TITLE: **AP1000 DCD Impacts to Support COLA Standardization**

**APP-GW-GLR-134**  
**Revision 0**

# **AP1000 Standard Combined License Technical Report**

## **AP1000 DCD Impacts to Support COLA Standardization**

Figure 4.3-1

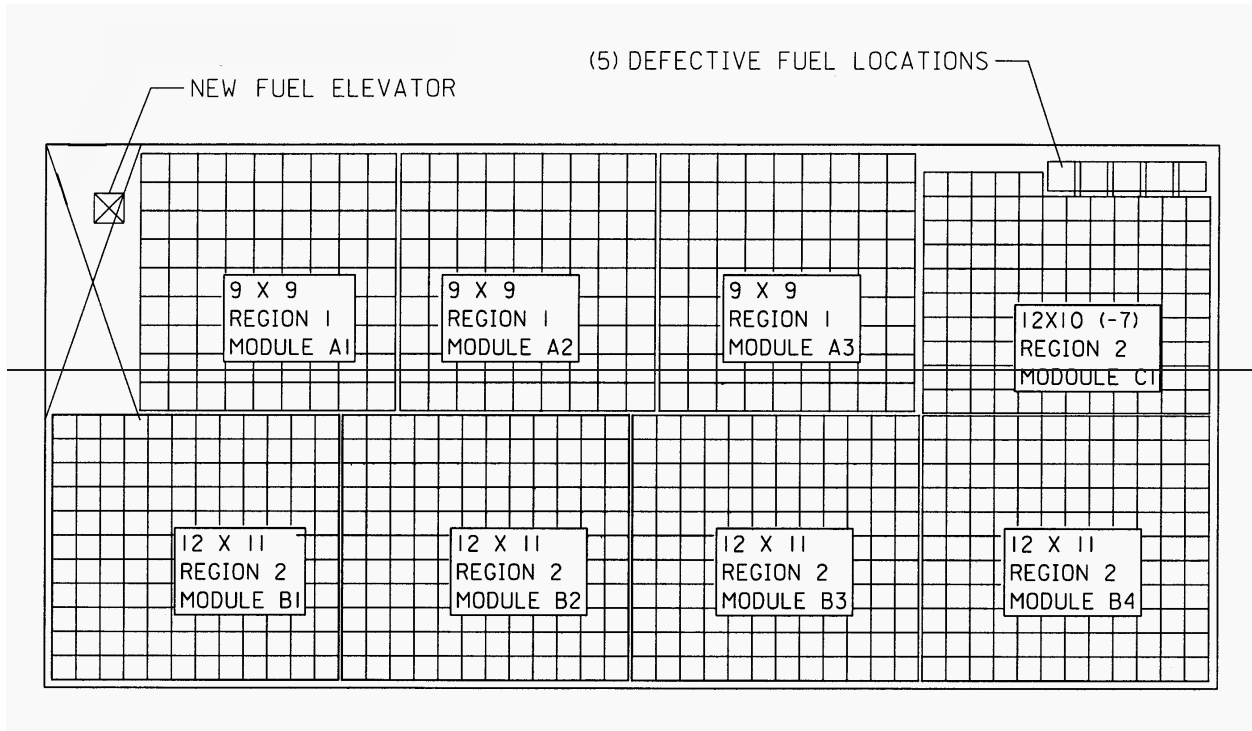
NRC100 contains corrections (typos) to TS 4.3.1 and Figure 4.3-1 of DCD Revision 16. The word "an" in the following statement will be changed to the word "any" in DCD Revision 17. "New or partially spent fuel assemblies with an discharge burnup may be allowed unrestricted storage in Region 1 and defective Fuel Cells of Figure 4.3-1". Figure 4.3-1, the word "module" was misspelled.

Figure 18.2-3

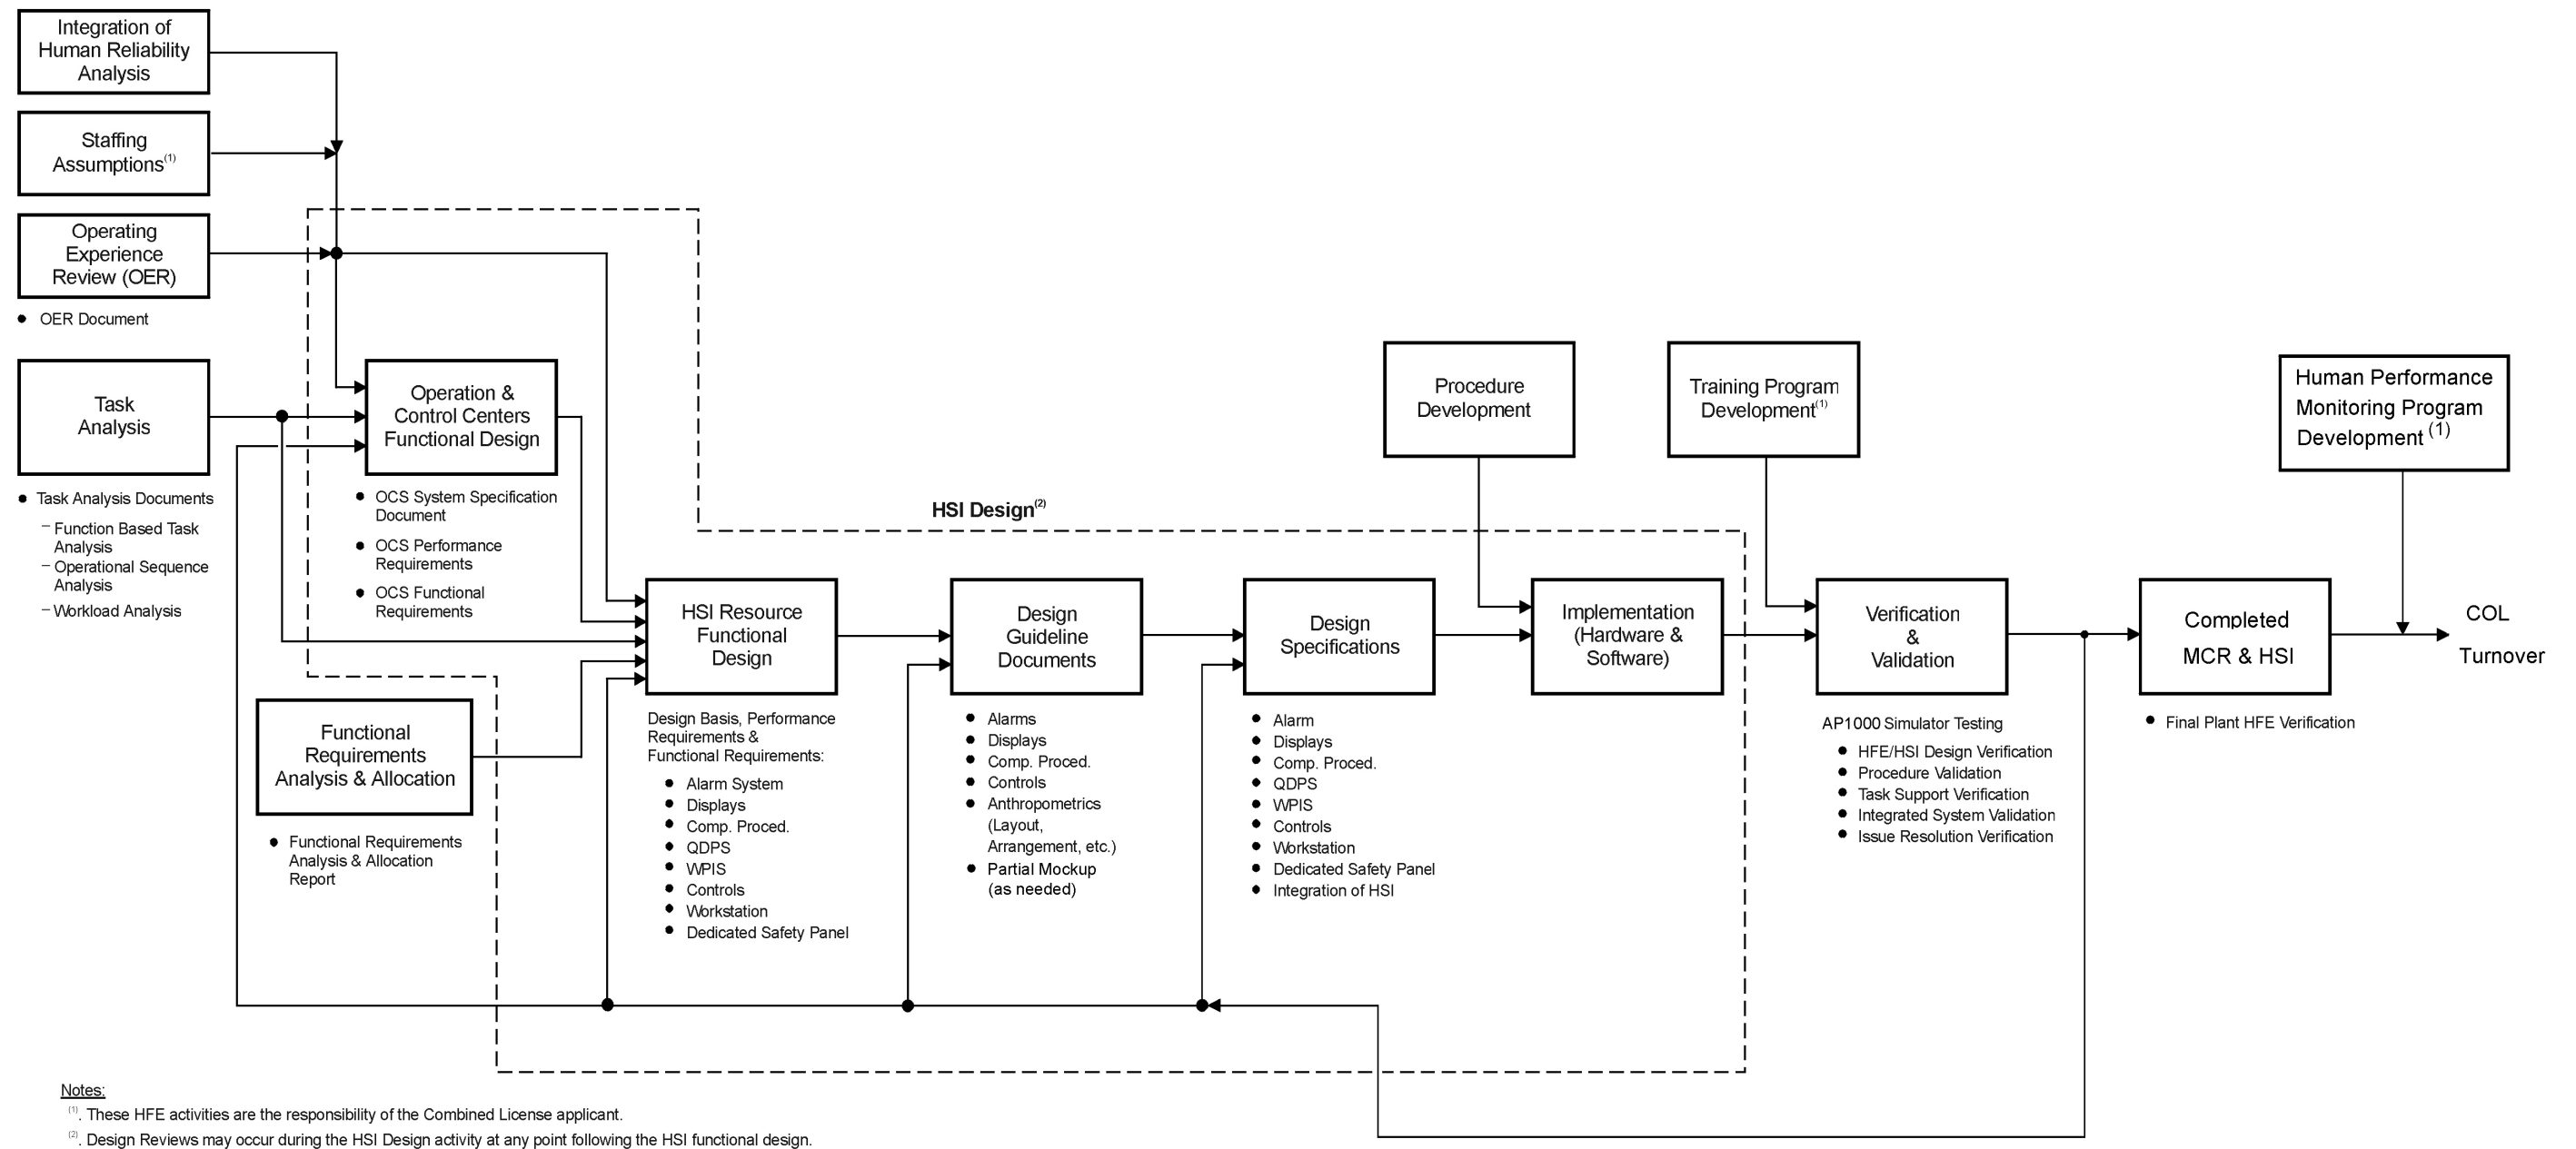
NRC065 contains an editorial correction to delete the parenthetical reference to Note 1, (1), in the box containing the words "Procedure Development" on DCD Figure 18.2-3

The basis for this deletion is Revision 1 of Technical Report 70, APP-GW-GLR-040, which closes COL Applicant actions with respect to Operating Procedure development. In addition, this deletion will ensure that Figure 18.2-3 of the DCD is consistent with Table 1.8-2 which clearly states that, with respect to COL Information Item 18.9-1, there are no COL Applicant or COL Holder actions required.
